Access Compliance Report

Public Rights-of-Way

(Curb Ramps)

Intersection ID: 2755	Main Street: BELL'S MILL_DR	Cross Street: RIDGEFIELD_DR	Location: W
ADA ID: C07F88E16E13	Ramp Type: Perp	Initial Pass/Fail: Fail	Overall Compliance: No
Severity Score: 18.75			
Codes/Mitigation Info/Possible Solution		Field Measurements/Component Compliance

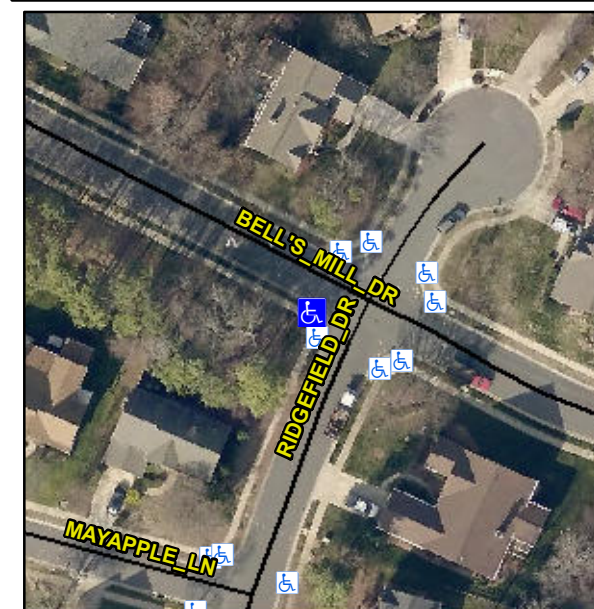
R304.5.1

Compliance	Description	Data	Compliance	Description	Data
N/A	Ramp Length (in)	52.0	Yes	Ramp Slope (%)	7.6
No	Ramp Width (in)	35.0	Yes	Ramp XSlope (%)	3.0
N/A	Flare Type LT	N/A	N/A	Flare Type RT	N/A
N/A	Flare Slope LT (%)	N/A	N/A	Flare Slope RT (%)	N/A
N/A	Flare Traversable LT?	N/A	N/A	Flare Traversable RT?	N/A
N/A	Landing Length (in)	N/A	N/A	DWS Provided?	N/A
N/A	Landing Width (in)	N/A	N/A	DWS Contrast?	N/A
N/A	Landing Slope (%)	N/A	N/A	DWS Length (in)	N/A
N/A	Landing X Slope (%)	N/A	N/A	DWS Full Width?	N/A
N/A	Landing Curb? (Y/N)	N/A	N/A	DWS Offset (in)	N/A
N/A	Shared Landing?	N/A			
N/A	Gutter Ponding?	N/A	N/A	Gutter Slope (%)	N/A
N/A	Gutter Lip Ht (in)	N/A	N/A	Gutter X Slope (%)	N/A
N/A	Painted X Walk1?	No	N/A	Painted X Walk2?	N/A
	X Walk 1 Direction	To NE		X Walk 2 Direction	N/A
N/A	X Walk 1 Width (in)	N/A	N/A	X Walk 2 Width (in)	N/A
	X Walk 1 Slope (%)	5.3		X Walk 2 Slope (%)	N/A
	X Walk 1 X Slope (%)	4.0		X Walk 2 X Slope (%)	N/A

Remove & Replace Entire Ramp.
